RESPONSE TO QUESTIONS

Correspondence Reference Number: 4093
731 Confirmation Number: TC555372
Date of Original Email: 05/07/2002

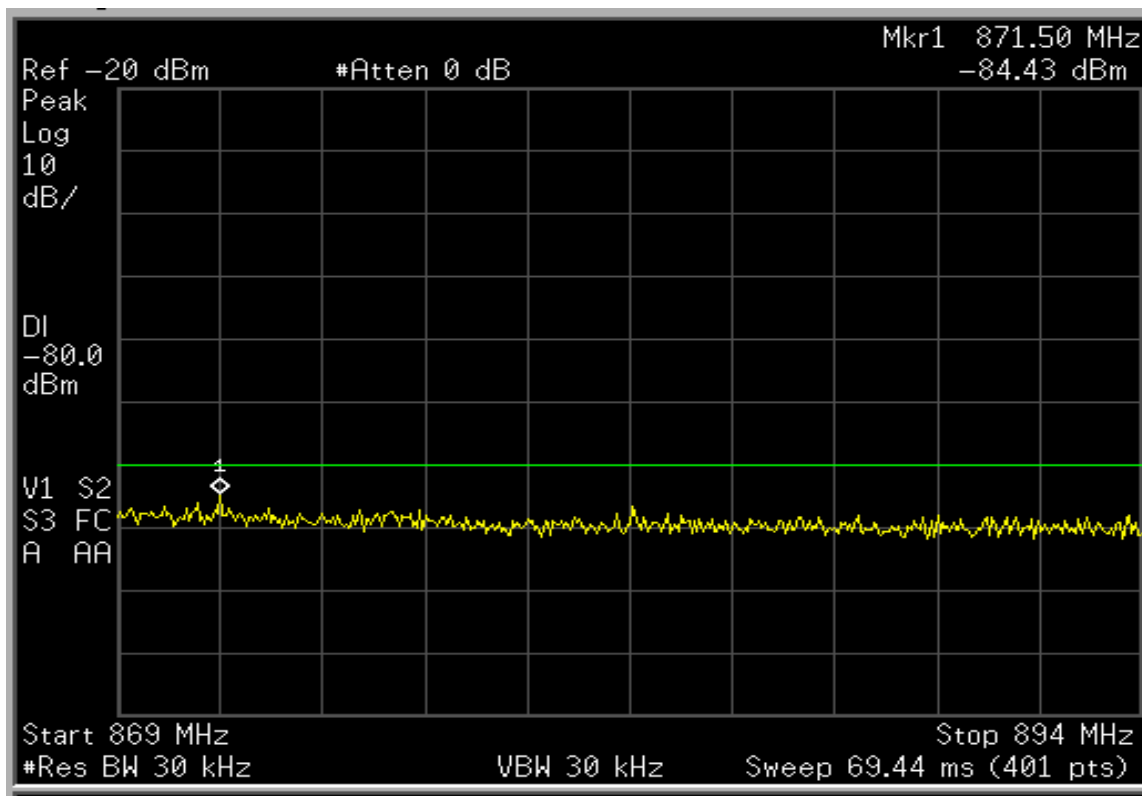
2) Measurement data showing compliance with 22.917(f) while in the 800 MHz CDMA mode.

RESPONSE: Refer to the following plot.
